Staff Report

Meeting Date: October 10, 2019 (Prepared October 3, 2019)

Item: 1310 & 1340 N. Pacific Highway “Pacific Valley Apartments” (DR 2019-03, PLA 2019-03, & VAR 2019-02)

1 SITE PLAN
 SCALE: 1"=40'-0"

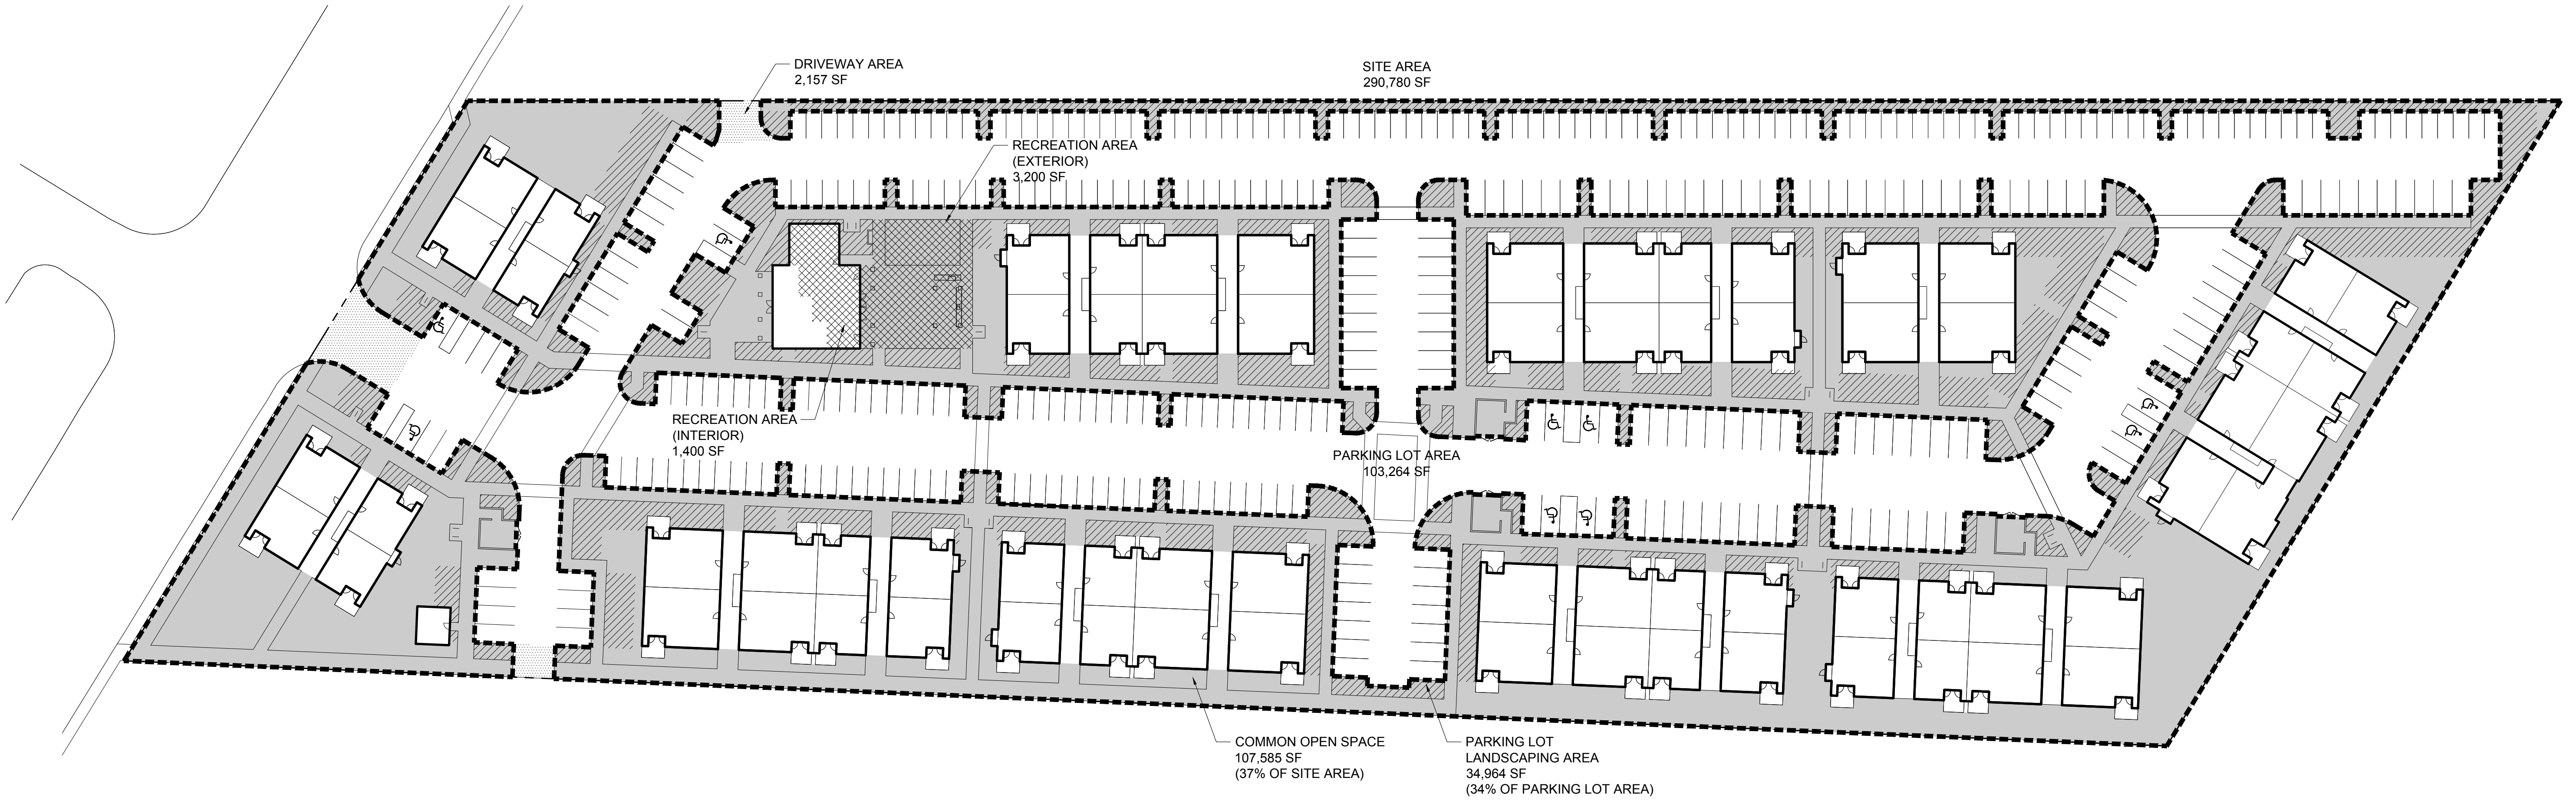
The ratio yields (204 dwellings x 2 stalls) = 408 stalls. The site plan (plan sheet Exhibit 2) illustrates and note 382 stalls, fewer than the minimum requirement and averaging 1.87 stalls per dwelling. The applicant submitted a variance request.
